ADDENDUM NO. 2

FEBRUARY 28, 2024

Staunton City Public Schools, VA
Shelburne Middle School Additions and Renovations
CRA Project No. 3636

PARTIAL LOWER LEVEL AND
FIRST FLOOR PLAN -
RENOVATION
PLOT SCALE:
1/8" = 1'-0"
FILENAME:
DATE:
01/24/2023

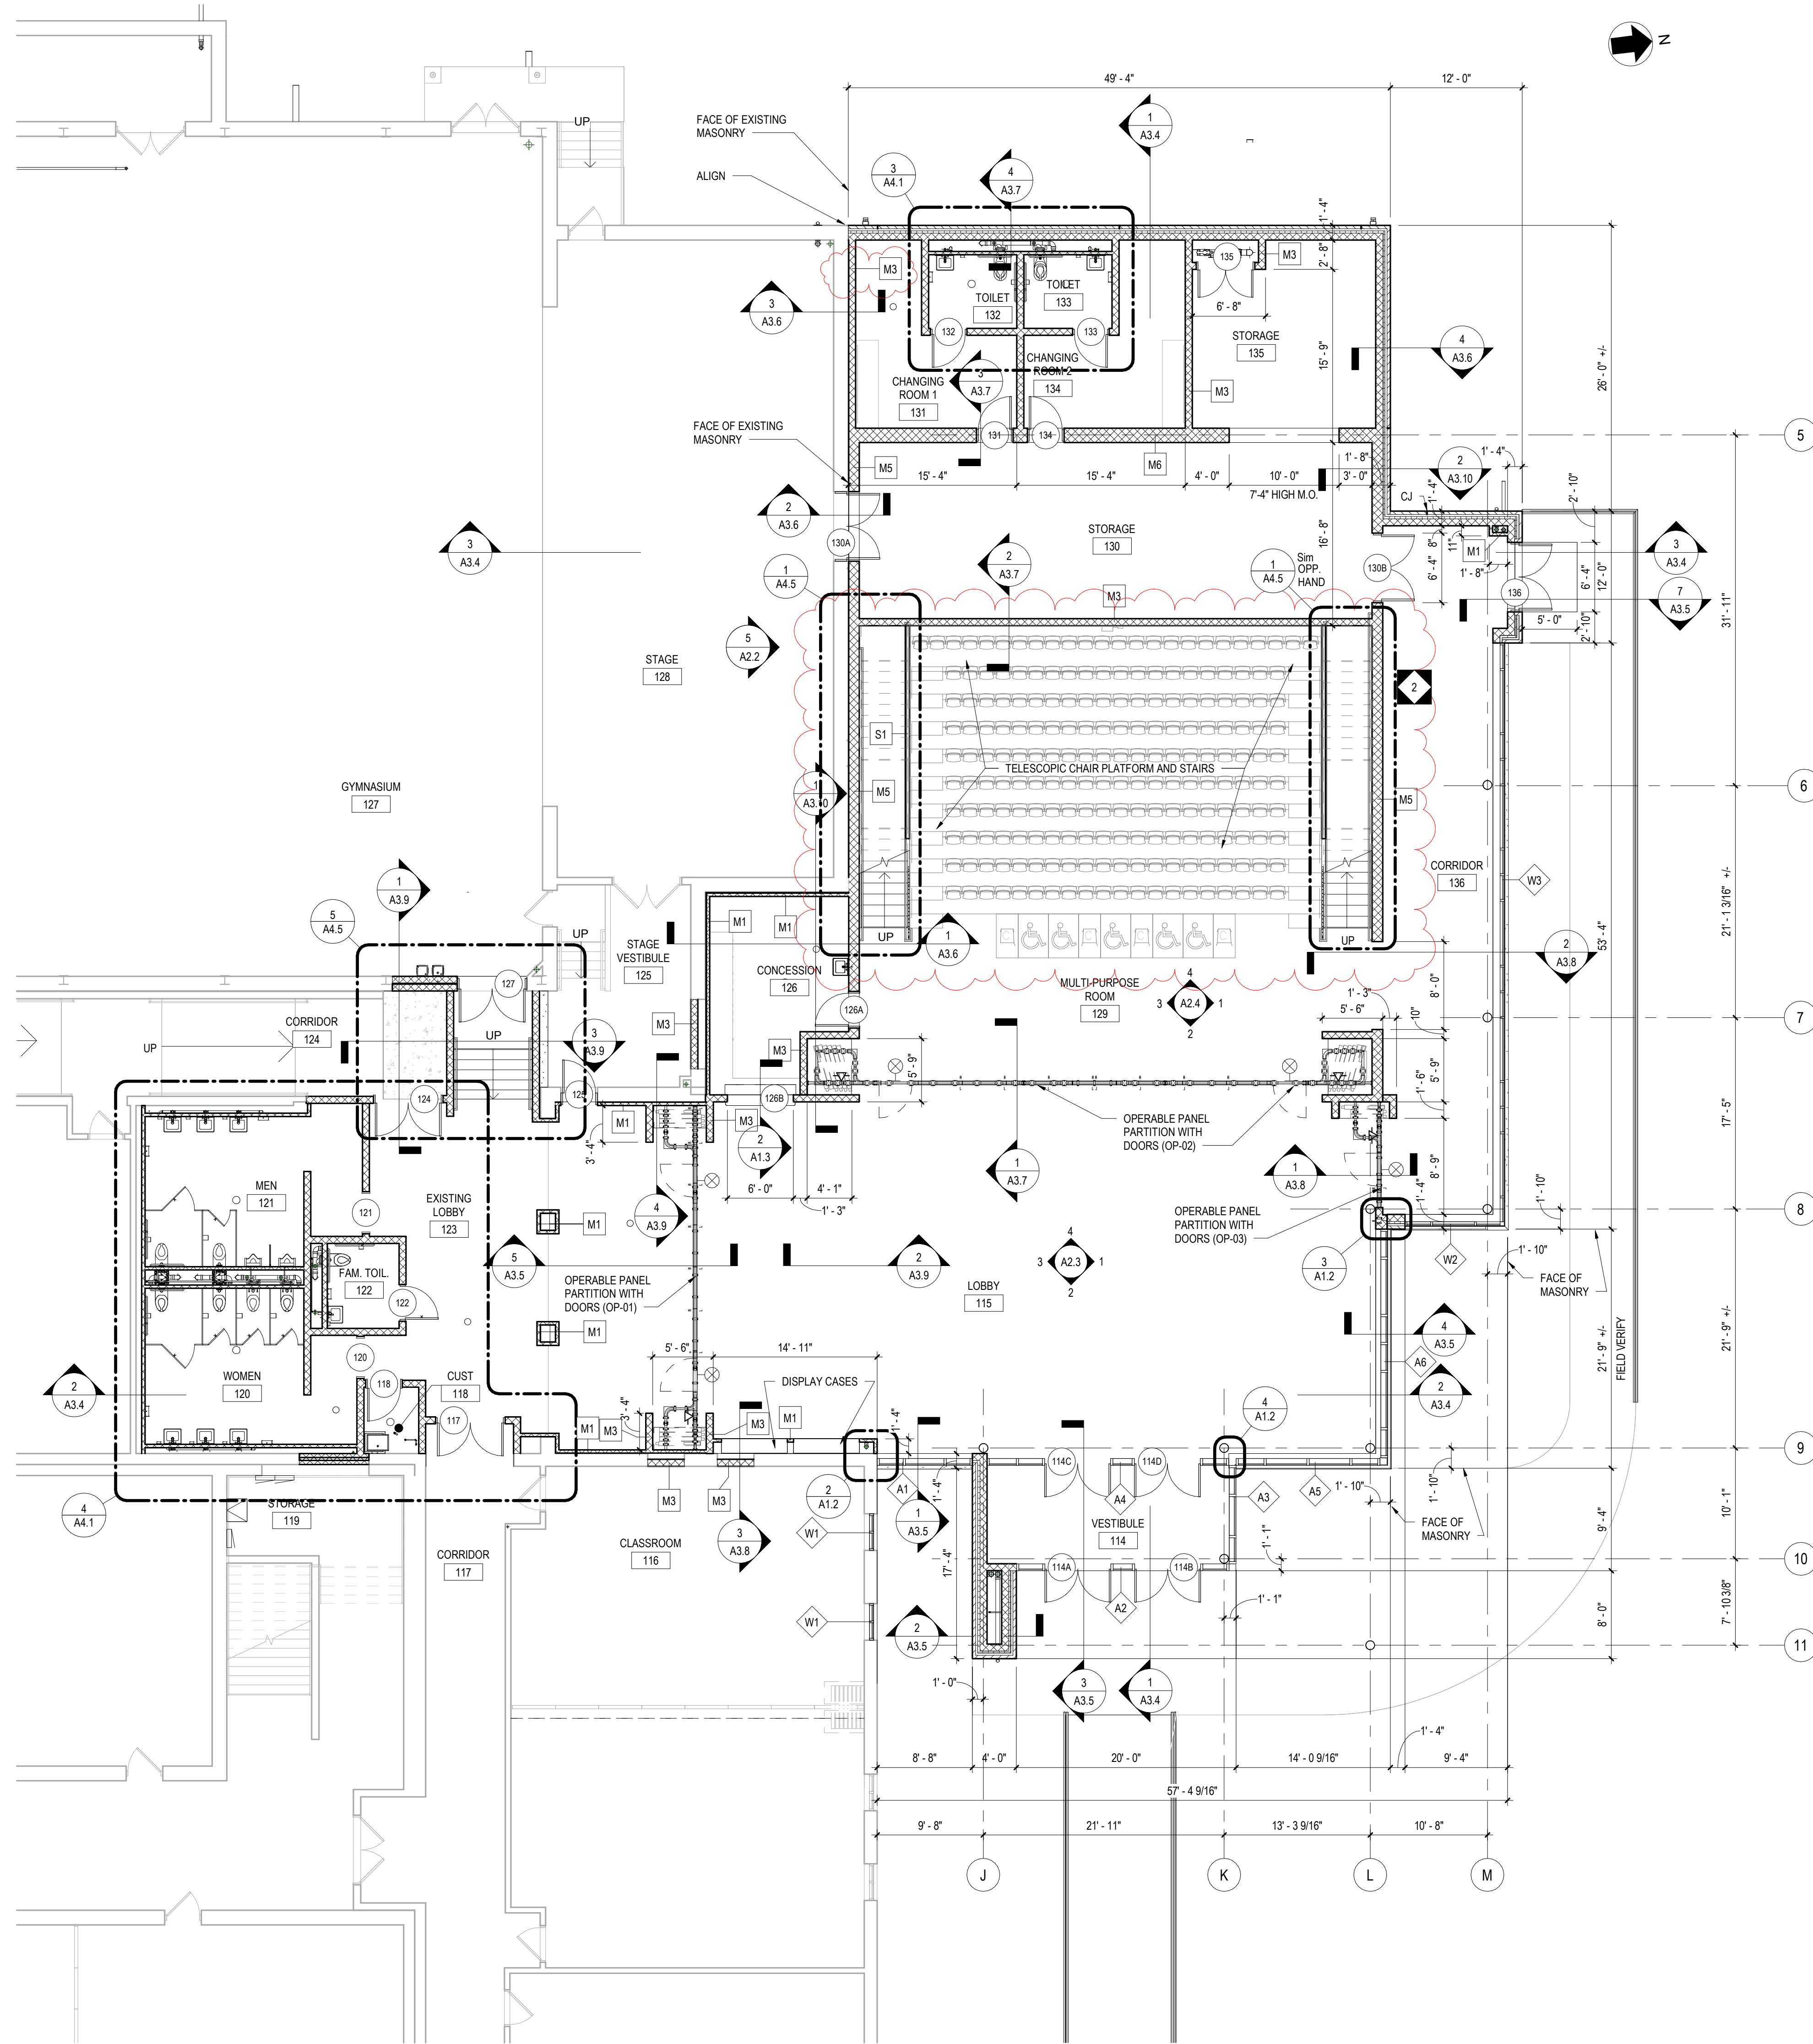
1. **DELETE** this sheet in its entirety and **REPLACE** with the attached sheet.
 - a. **REVISED** LAYOUT OF ADDED STORAGE IN Design Classroom 004.
